Pymble Ladies College Secondary Innovation Precinct (SSD-79146716)

Department of Planning, Housing and Infrastructure
Social Infrastructure Assessments

Prepared for IPC Meeting
2 July 2026

Figure | Tree removal / retention plan

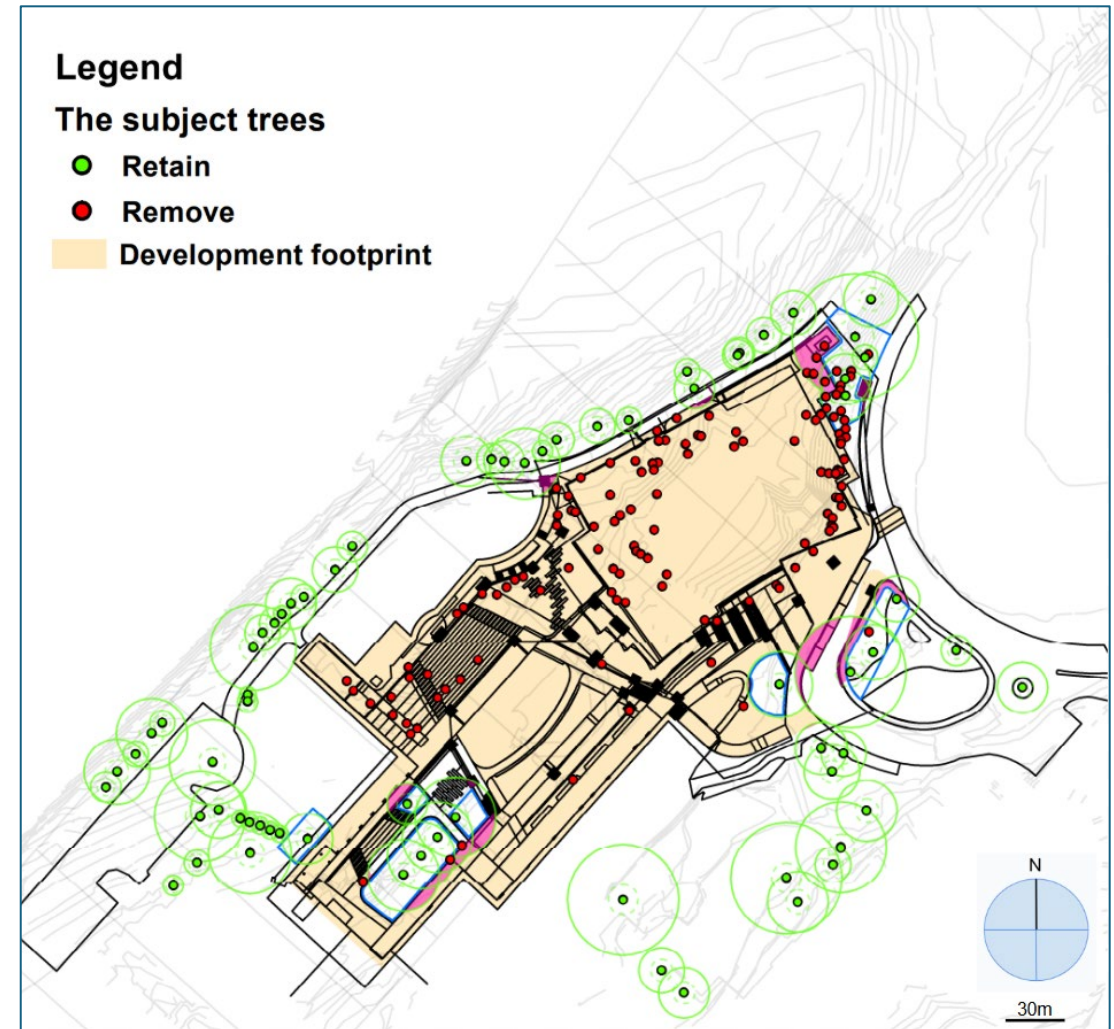
Biodiversity

Avoid and minimise

- Avoidance and minimisation analysis included:
 - alternative locations
 - reduced/redesigned building
 - increased height and split building options
 - wider campus relocation

Conditions

- Replacement planting to be consistent with BGHF species
- Appointment of a project arborist (supervision / tree protection)

Staff parking during construction

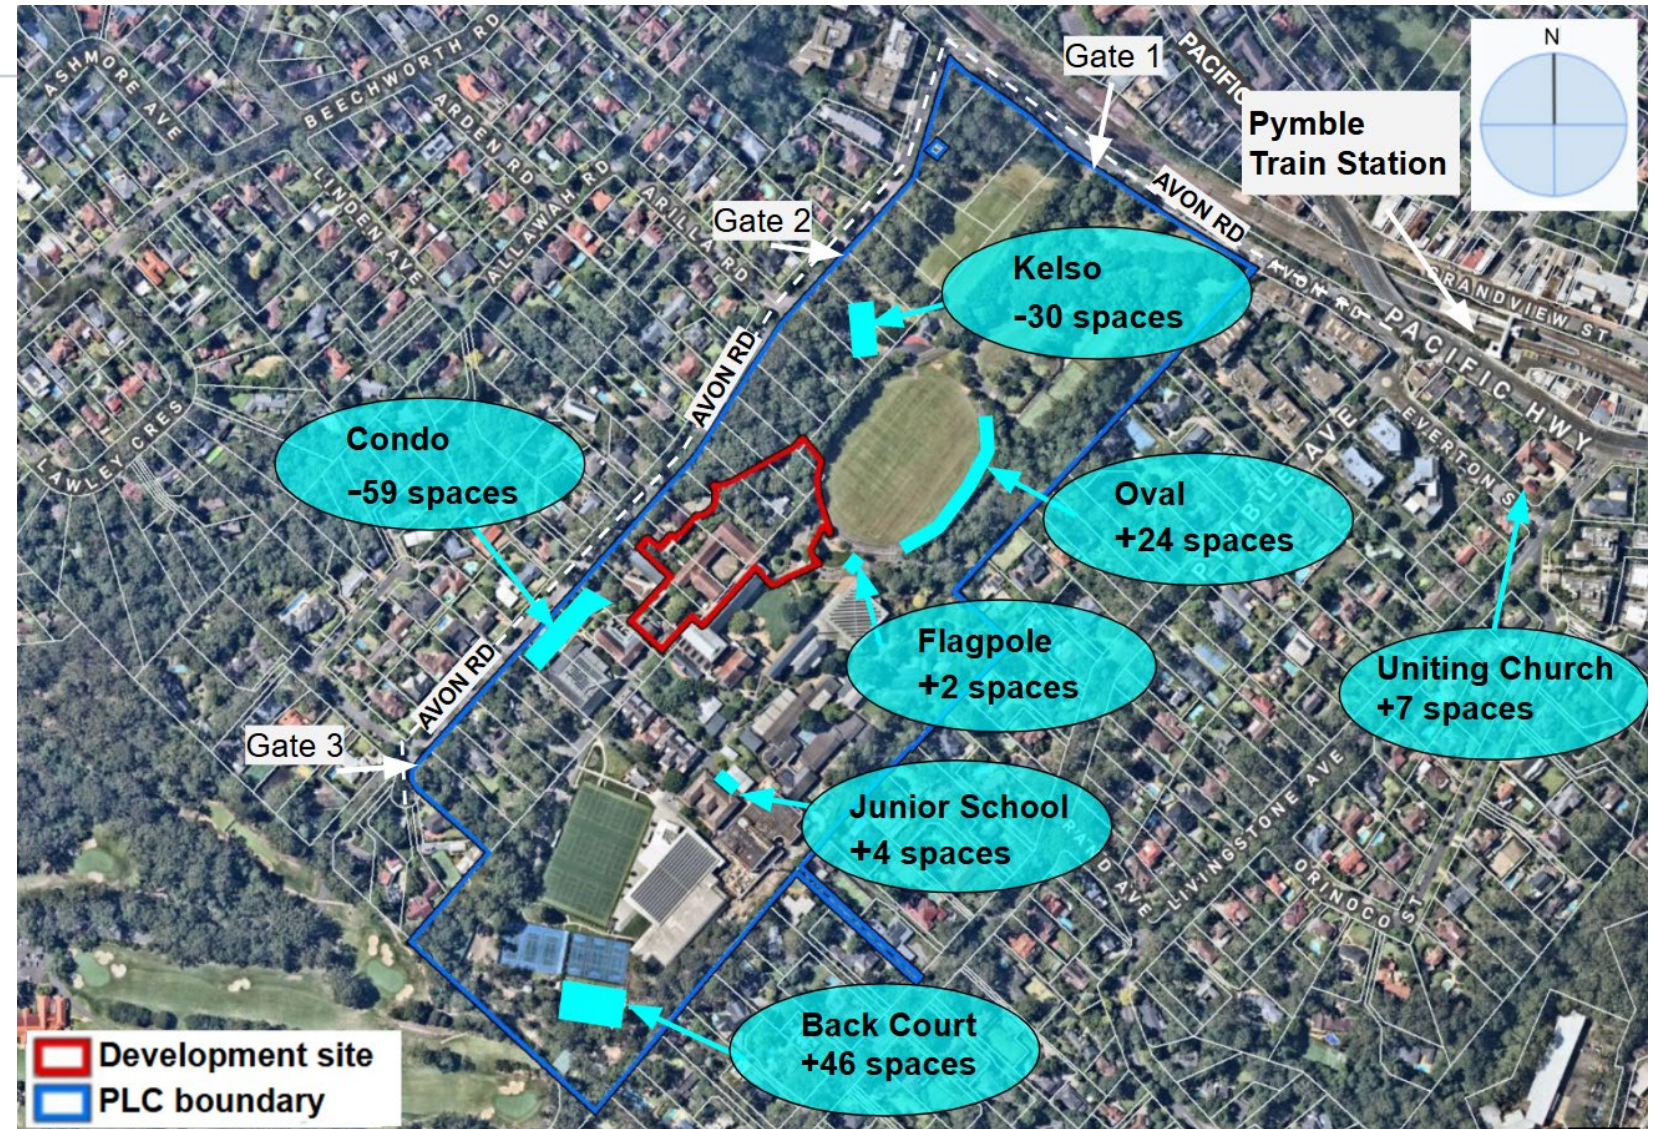
- During construction, staff parking would be temporarily re-shuffled
- 7 temporary spaces off site - Gordon-Pymble Uniting Church.

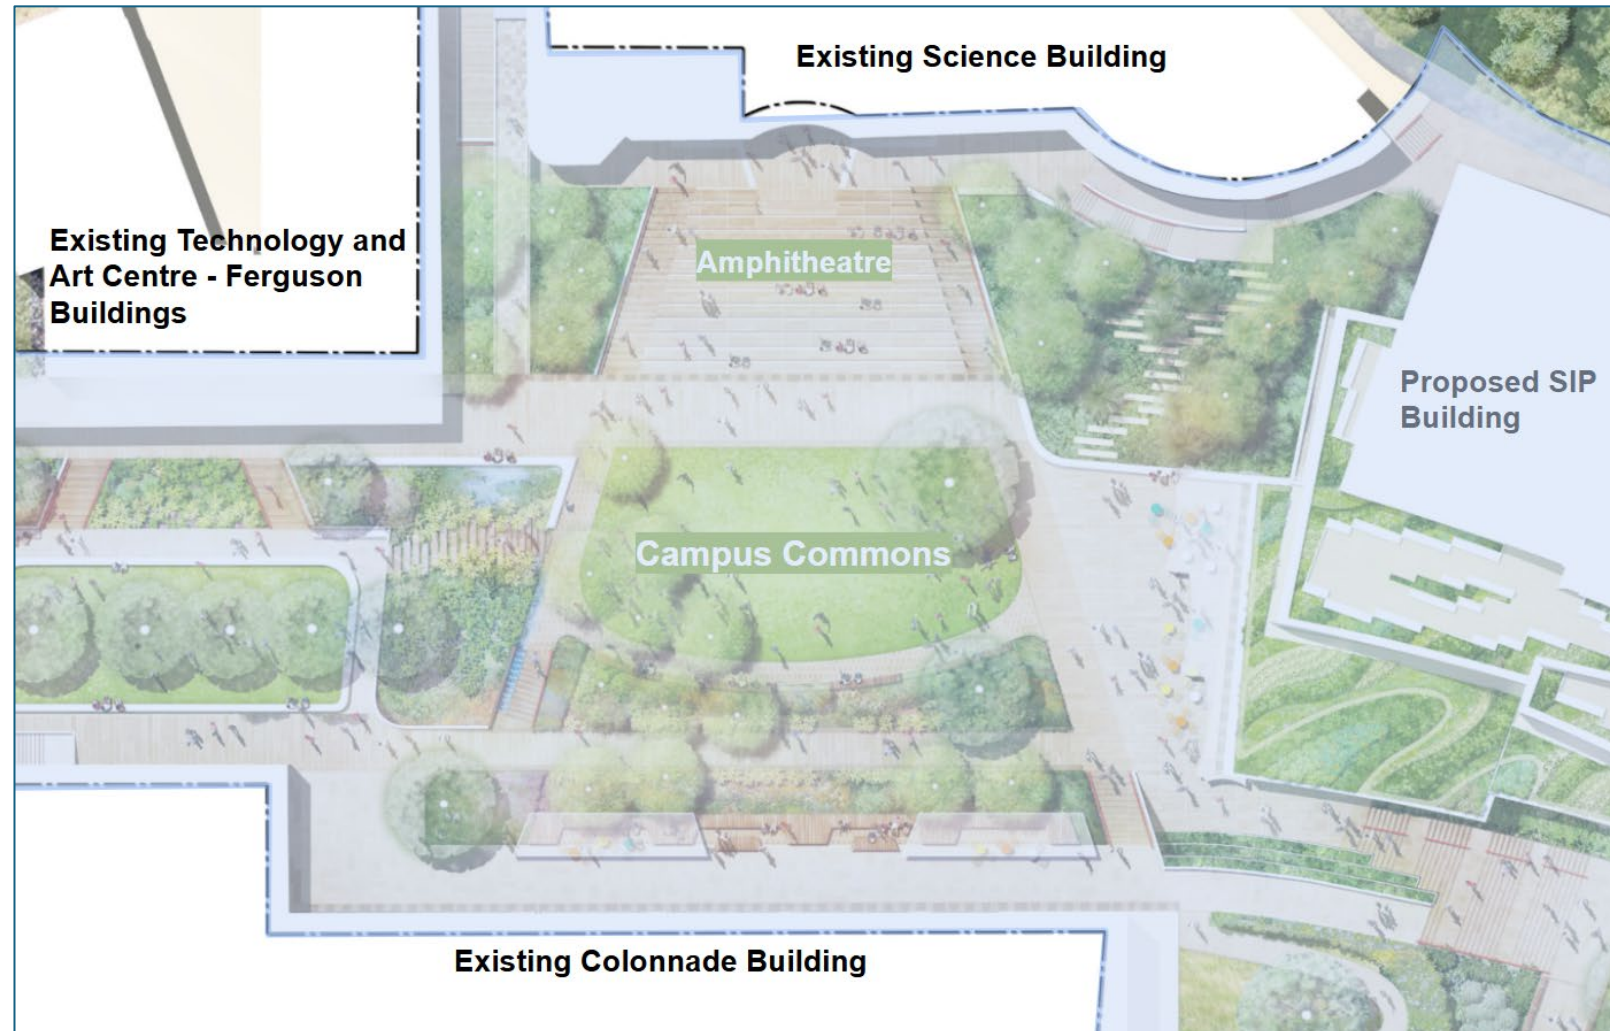
Construction noise

- Existing school buildings situated close to the SIP.

Conditions

- Noise modelling of all sensitive receivers including retained school buildings before works
- Communication protocols.
- Standard construction hours.

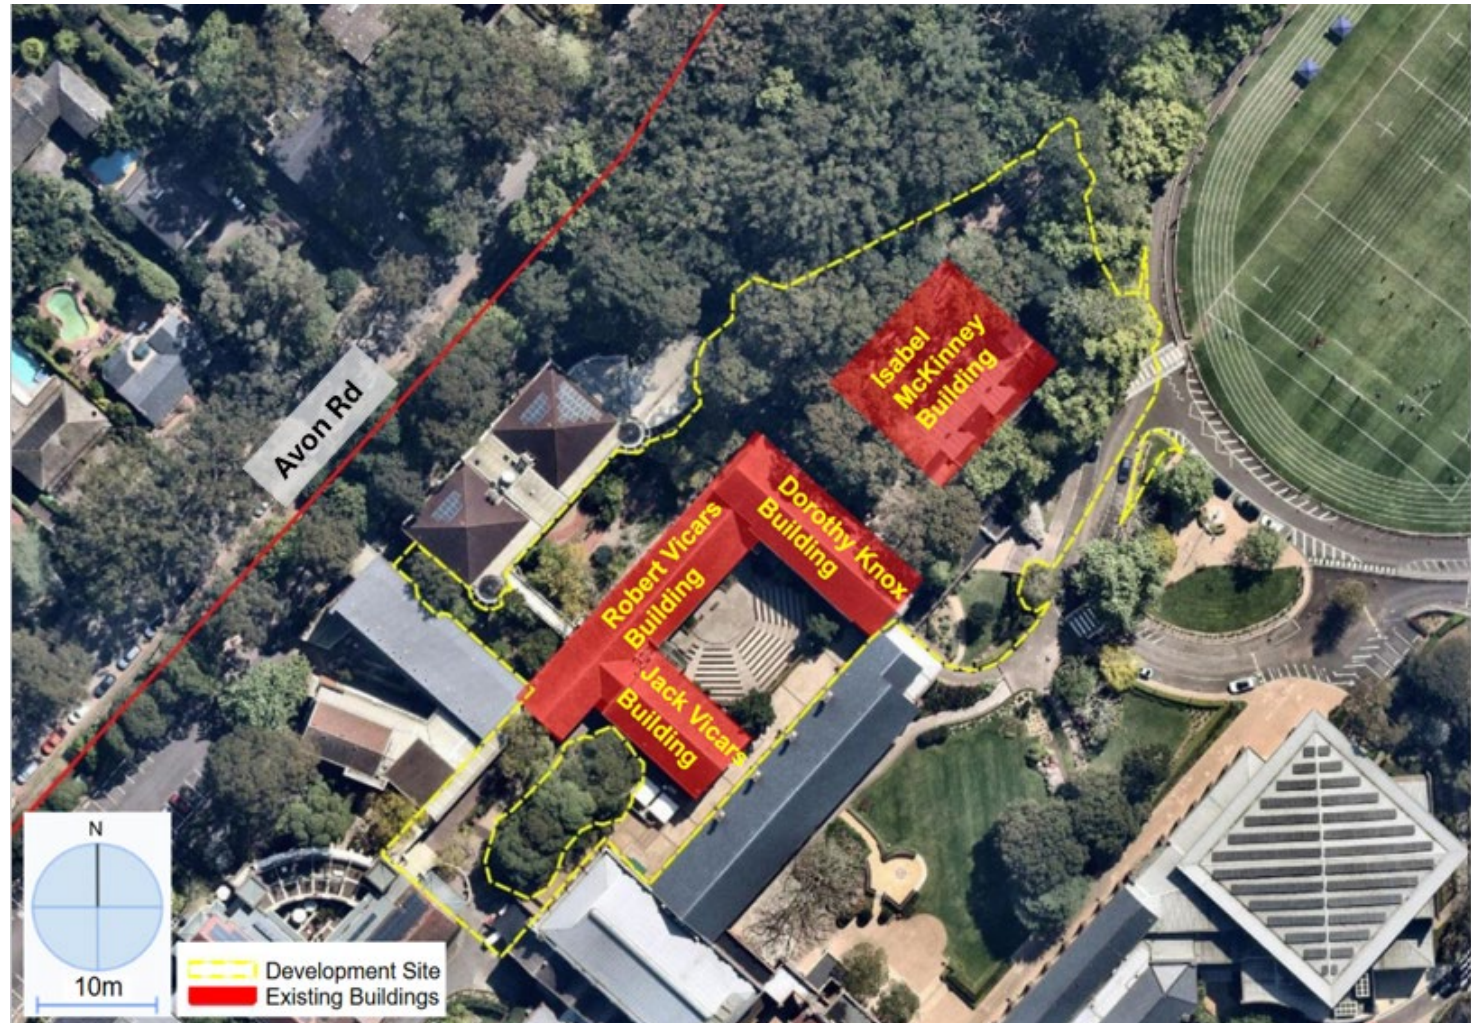
Contamination

- Existing building footprints not tested.
- A Remediation Action Plan required if contamination above safe levels is found.

Conditions

- Conditions are recommended to address handling and disposal of asbestos, an unexpected finds protocol, and further site investigations to confirm the full nature and extent of contamination within the development site.
